## Product Change Notification / ASER-02NIOC250

CCB 6136 Final Notice: Qualification of MMT as an additional assembly site for selected MIC460xx, MIC410xx and MIC380xx device families available in 8L SOIC (3.90mm) package.

PCN #: ASER-02NIOC250

# Pre and Post Summary – Bondshell Comparison

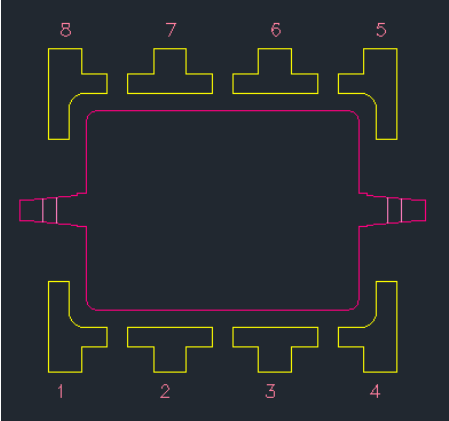
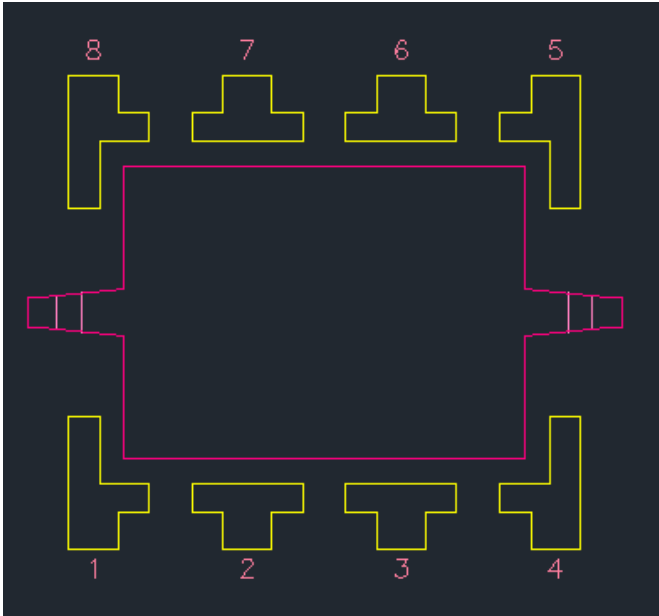
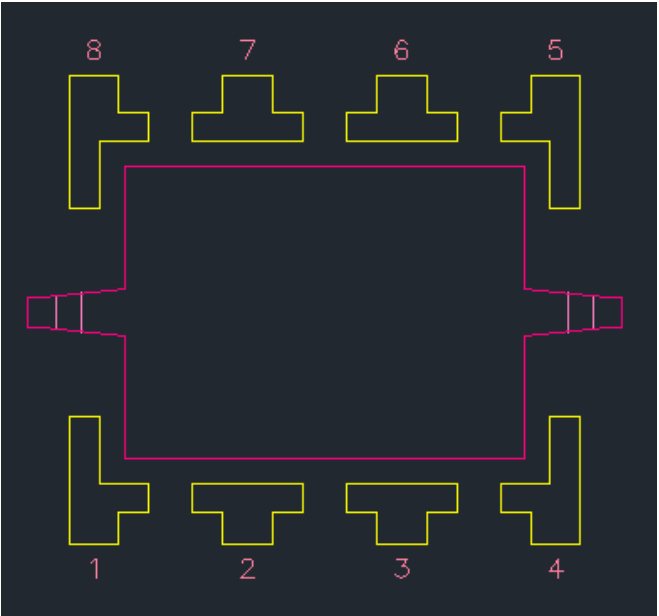
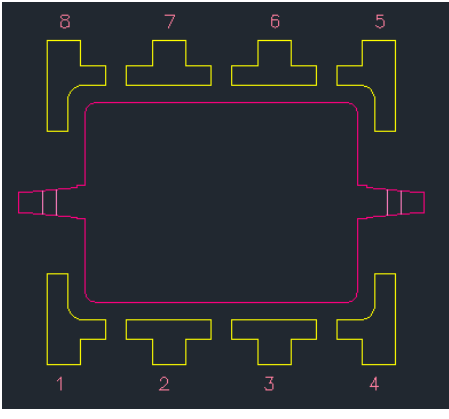
STAR		UNIS		MMT	
	<b>Lead-Frame Material</b> A194				
	<b>Lead-Frame Material</b> CDA194	<b>Lead-Frame Material</b>	A194	<b>Lead-Frame Material</b>	CDA194

Note: C194, A194 or CDA194 Lead-Frame material are the same, it is just a MCHP internal labelling difference.
